25 November 2025

RE: WHITEHAVEN SOLAR FARM (SSD-66542218) – RESPONSE TO REQUEST FOR ADDITIONAL INFORMATION DATED 20 NOVEMBER 2025

Plate 2: Example of Vegetation Condition and Vegetation Integrity Score Ranges Before and After Partial Loss

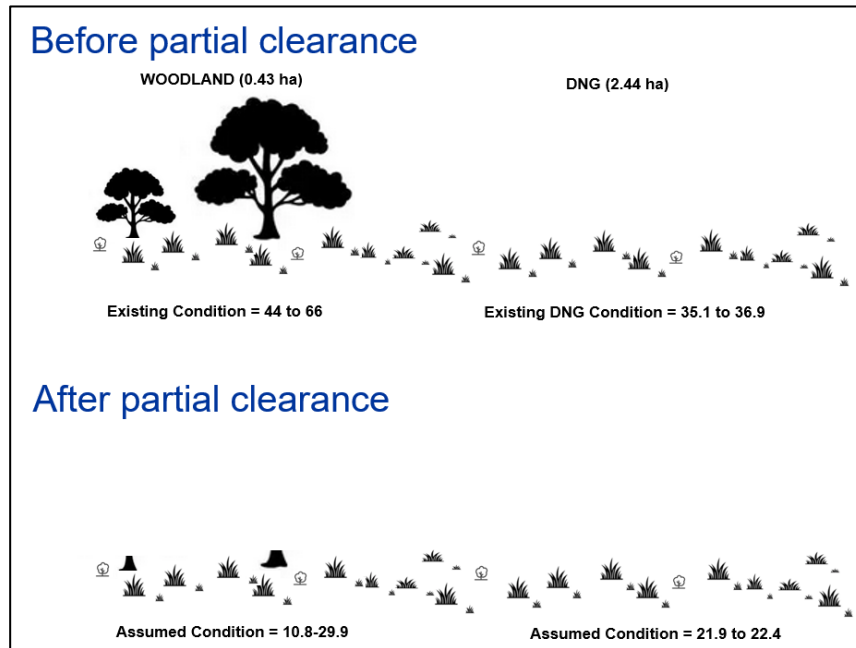
1. select clearing would be undertaken via chain-saw so trees and shrubs are the attributes that would be lost (Section 1.2 of the BDAR [Resource Strategies, 2024]);
2. other groundcover attributes would be maintained through management measures outlined in Table 16 of the BDAR (Resource Strategies, 2024) (e.g. site induction/access, clearing limits and weed control); and
3. the future vegetation integrity (VI) scores (after trees and shrubs removed) are conservatively less than the current VI score of the surrounding derived native grassland (Table 15 of the BDAR [Resource Strategies, 2024]) as shown in Plate 2.

It is recognised that scoring of partial loss in the Biodiversity Assessment Method Calculator (BAM-C) must include a reduction in VI score that is proportional to the amount or degree of partial clearing and associated future management. It must reflect any likely degradation from changed land-use patterns (e.g. increased threats) and/or future management proposed (e.g. to enable recruitment). However, as noted above, the Project is across a number of paddocks presently used for agriculture including livestock grazing and dry land cropping. As described in Section 3.8 of the Project Environmental Impact Statement, the Project's design would include accommodation of agrisolar practices, particularly sheep grazing, which would be subject to an initial trial to confirm suitability and carrying capacity on the Project land.
